December 14, 2001
LIC-01-0114

**SUBJECT: Fort Calhoun Station Unit No. 1 License Amendment Request,
"Pressure and Temperature (P-T) Limit Curve for 40 Effective Full Power
Years (EFPY)"**

**Fort Calhoun Station's Evaluation
For
Request for Pressure and Temperature Limit Curve for 40 EFPY**

Figure 2-1

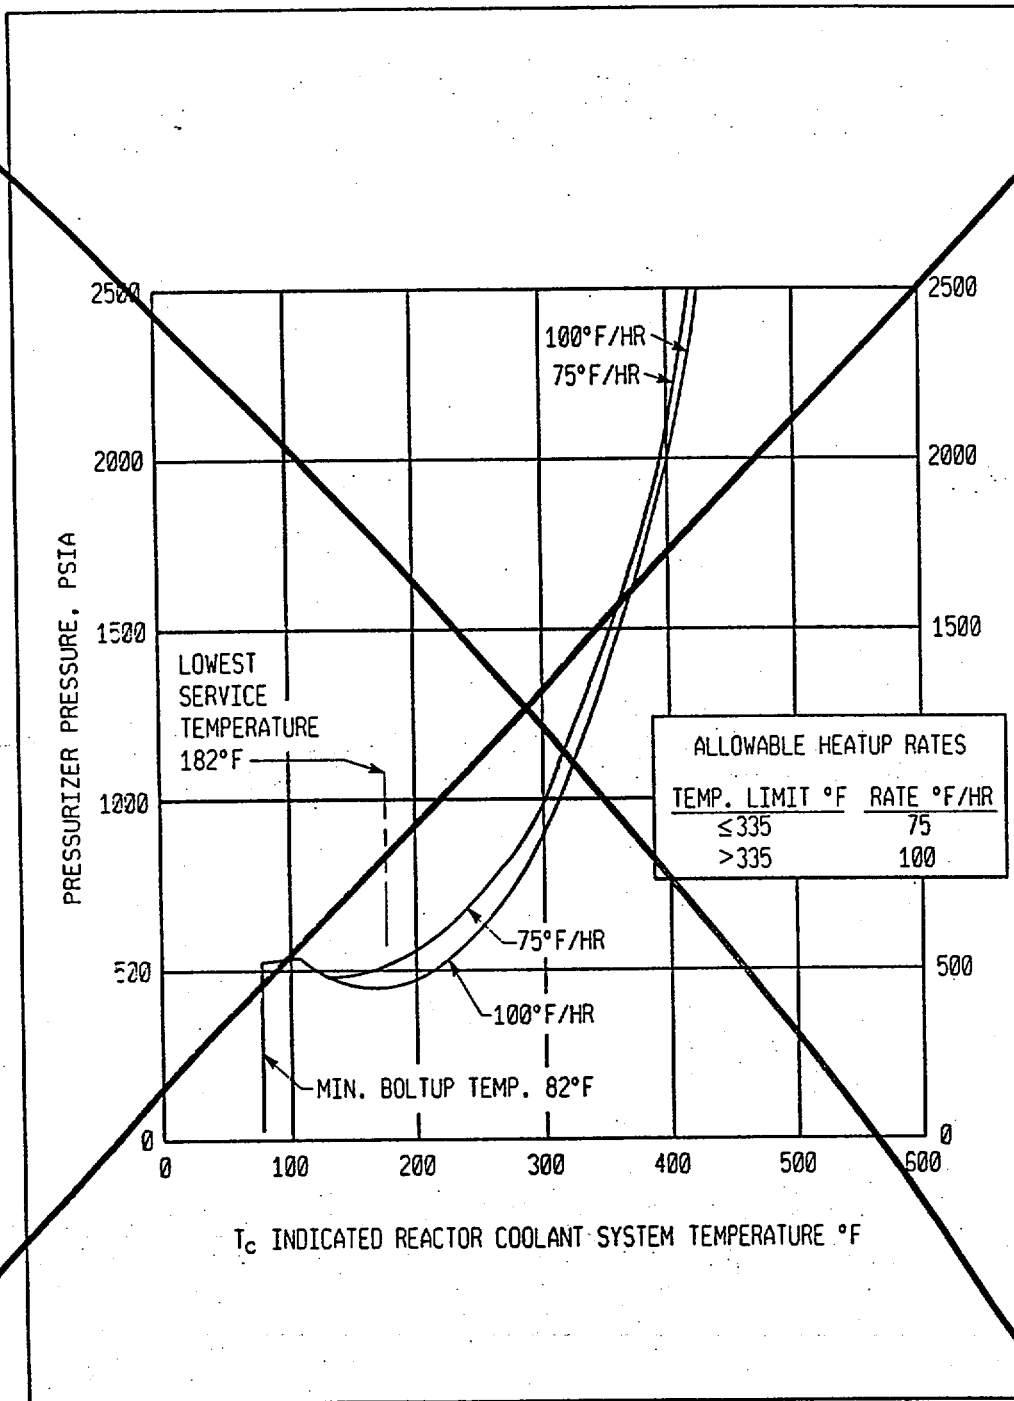
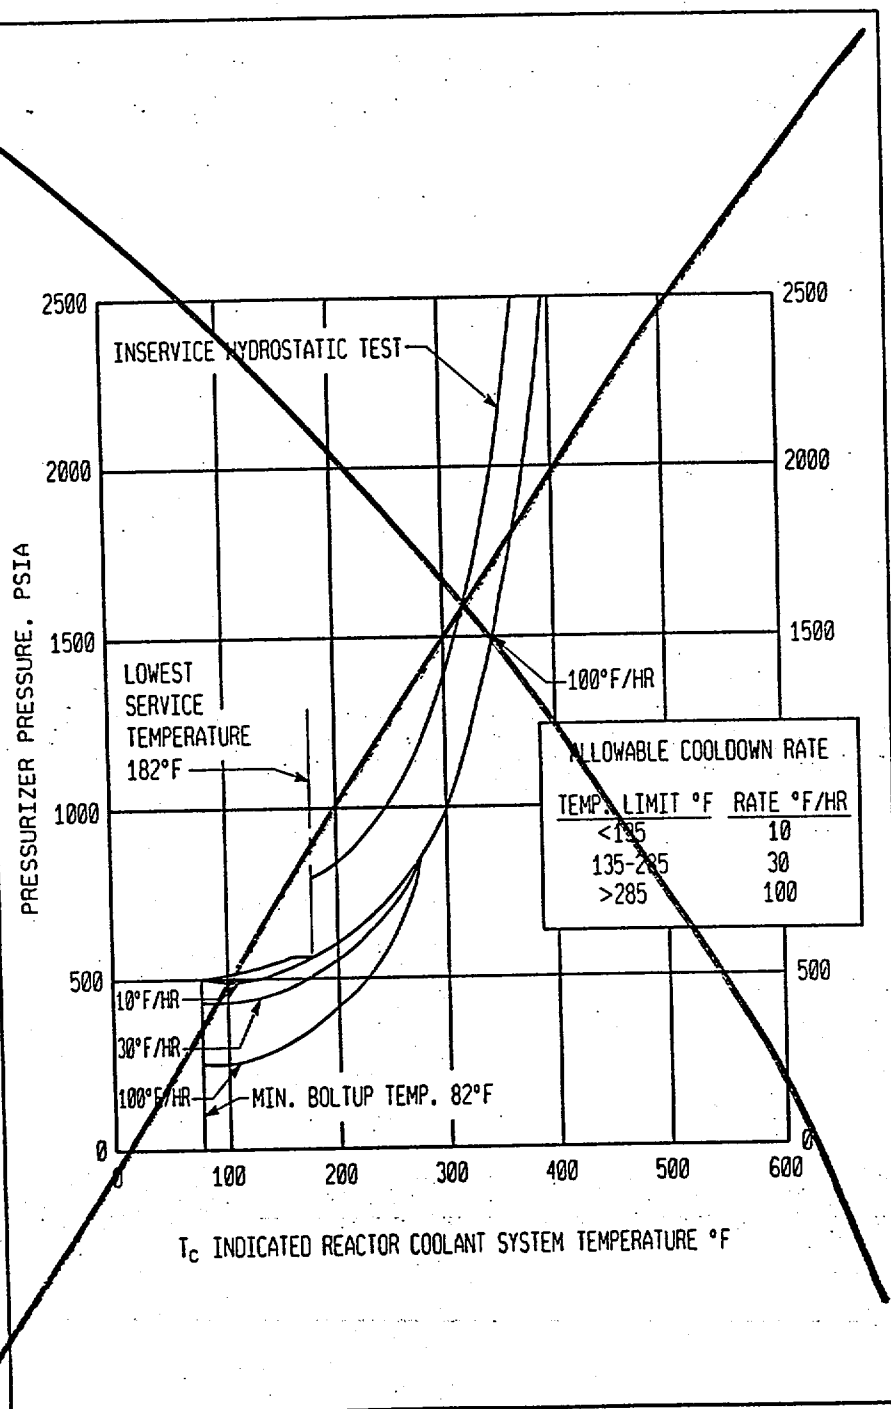
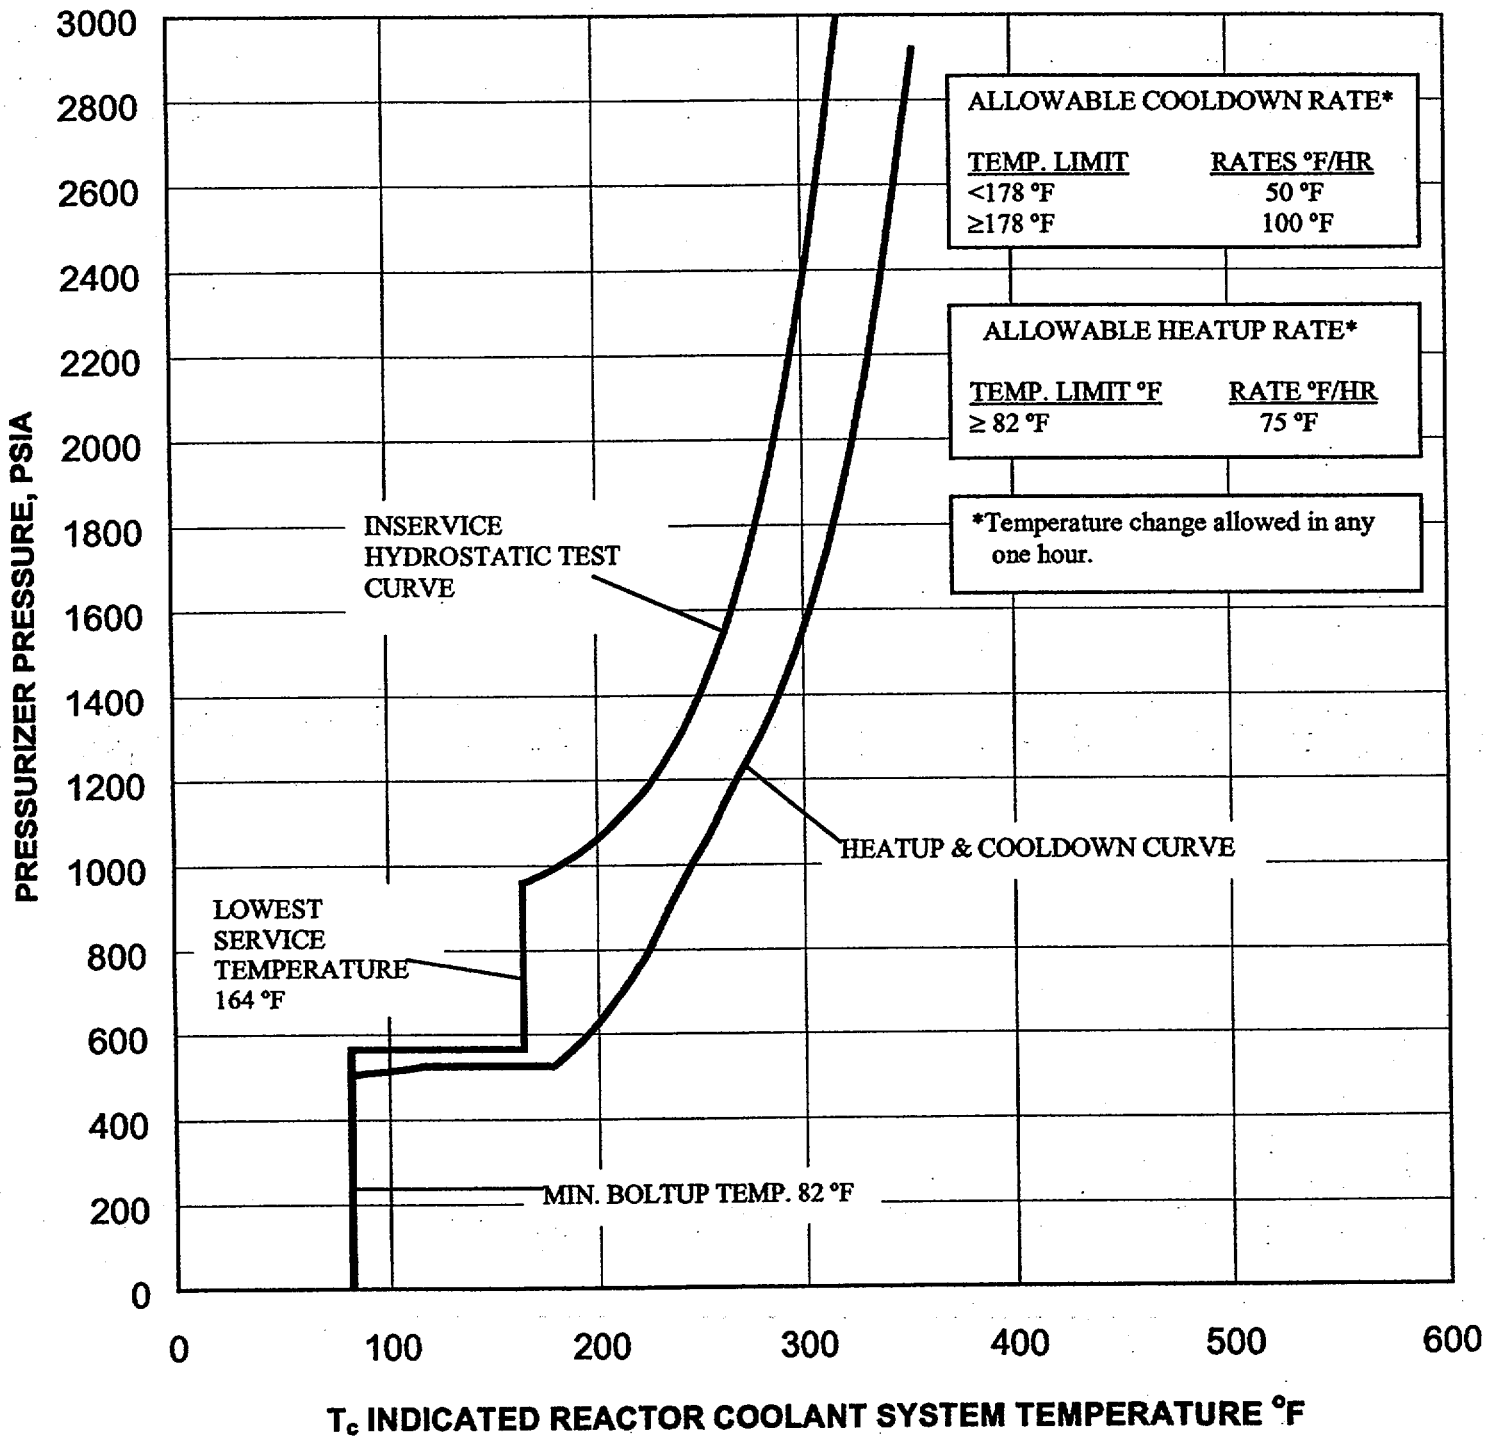
The proposed changes include replacement of TS Figures 2-1A (RCS Pressure - Temperature Limits for Heatup) and 2-1B (RCS Pressure - Temperature Limits for Cooldown) with the single composite TS Figure 2-1 (RCS Pressure - Temperature Limits for Heatup, Cooldown, and Inservice Test). Specifically, this new figure applies the use of American Society of Mechanical Engineers (ASME) Code Case N-640 which allows the use of the conservative, but less limiting, lower bound of static initiation critical stress intensity factor (K_{IC}) versus the lower bound of static, dynamic, and crack arrest critical stress intensity factor (K_{IA}). OPPD did not invoke the use of ASME Code Case N-514 in its current low temperature overpressure protection (LTOP) analysis, which allows the P-T limit curve to be exceeded by an additional 10% (Reference 10.3). The current LTOP analysis is applicable to this proposed pressure and temperature (P-T) limit curve. Therefore, Technical Specification 2.3(3) does not need to be revised. Furthermore, OPPD will ensure that any new LTOP analysis will ensure that the setpoint curve will prevent the pressure excursion associated with a limiting LTOP pressurization event from exceeding 100% of this TS Figure. Additionally, the adjusted reference temperatures (ARTs) for the 1/4T (237.76°F) and 3/4T (187.97°F) location have been determined in accordance with Regulatory Guide 1.99, Revision 2, using a predicted fluence value of 2.15×10^{19} n/cm² which corresponds to 40 EFPY as stated in Table 6.2-1 of Reference 10.1. This predicted fluence value is applicable to the limiting weld for Fort Calhoun Station for the 3-410 axial welds using weld wire heat number 12008/13253 at the critical 60° location (Reference 10.2). Due to the application of these ART values with its associated predicted fluence value, Technical Specification 2.1.2(6)(a) will be changed to

In Summary, the proposed amendment replaces TS Figures 2-1A (RCS Pressure - Temperature Limits for Heatup) and 2-1B (RCS Pressure - Temperature Limits for Cooldown) with the single TS Figure 2-1 (RCS Pressure - Temperature Limits for Heatup and Cooldown). Additionally, it changes the lowest service temperature to 164°F and the basis for the minimum boltup temperature. The Basis section for Technical Specification

The reactor coolant pressure shall be limited during plant operation in accordance with Figure 2-1A and 2-1B and as follows:

- (1) Allowable combinations of pressure and temperature (T_c) for a specific heatup rate shall be below and to the right of the applicable limit lines as shown on Figure 2-1A.

E. ~~The temperature at which the heatup and cooldown rates change in Figures 2-1A and 2-1B reflects the point at which the most limiting heatup and cooldown rates with respect to the inlet temperature (T_i) change.~~

Therefore, the minimum pressure would be 564 psia for RCS temperatures $< 210^{\circ}\text{F}$, and 558 psia for RCS temperatures $\geq 210^{\circ}\text{F}$. Additionally, these pressure correction factors are incorporated into the limit lines of TS Figure 2-1.

The ARTs used in TS Figure 2-1 were calculated in accordance with Regulatory Guide 1.99, Revision 2, Regulatory Position 1.1 (Reference 10.6). They use a predicted base metal surface fluence value of $2.15 \times 10^{19} \text{ n/cm}^2$ (Reference 10.1). This value corresponds to the predicted fluence value associated with 40 EFPY of reactor operation to the 60° location. The 60° location corresponds to the critical 3-410 axial weld for tandem weld wire heat 12008/13253 (Reference 10.2). The ARTs that were used in TS Figure 2-1 are as follows:

TS Figure 2-1 was developed using W/CE's methodology for P-T curve development (Reference 10.5), Reference 10.4, Section XI, Appendix A and G, ASME Code Case N-640, and 10 CFR 50 Appendix G. W/CE's methodology was reviewed and approved in References 10.7 and 10.8. TS Figure 2-1 has incorporated the following information:

- 1) A conservative indicated minimum boltup temperature of 82°F. TS Figure 2-1 has been analyzed to an indicated temperature of 64°F that will be requested to be used when the LTOP analysis is re-performed and submitted to the NRC for review.

- 2) An indicated lowest service temperature of 164°F.
- 3) An actual ART value at the clad to reactor vessel base metal interface is 261.56°F.
- 4) An actual ART value for the 1/4T position is 237.76°F.

- 5) An actual ART value for the 3/4 T position is 187.97°F.
- 6) An indicated LTOP-enable temperature at 350°F.
- 7) Pressure correction factors due to flow and elevation:
An actual RCS temperature < 210°F = 61 psi
An actual RCS temperature > 210°F = 67 psi

- 8) Pressure instrumentation uncertainty above an indicated RCS temperature of 350°F of 50 psi.
- 9) Temperature instrumentation uncertainty of 14°F.
- 10) A minimum pressure value of 564 psia for actual RCS temperatures < 210°F. (Note: The endpoint of the minimum pressure line corresponds to the lowest service temperature value of 164°F).

- 12) TS Figure 2-1 is a composite P-T limit curve that is a conservative blend of the limiting heatup or cooldown rate. The following heatup and cooldown rates must be followed to maintain the validity of TS Figure 2-1:

The heatup rate is limited to 75°F/hr for an indicated RCS temperature of 82°F and greater.

The cooldown rate is limited to 100°F/hr for an RCS temperature greater than or equal to 178°F. Below 178°F, it is limited to 50°F/hr.

The reactor coolant pressure shall be limited during plant operation in accordance with Figure 2-1 and as follows:

- (1) Allowable combinations of pressure and temperature (T_c) for a specific heatup rate shall be below and to the right of the applicable limit lines as shown on Figure 2-1.

- (a) Figure 2-1 is valid for a fast neutron ($E \geq 1\text{MeV}$) fluence of 2.15×10^{19} n/cm² which corresponds to 40 EFPY.
- (b) The limit line on the figures shall be updated for a new integrated power period as follows: the total integrated reactor thermal power from startup to the end of the new period shall be converted to an equivalent integrated fast neutron exposure ($E \geq 1\text{ MeV}$).
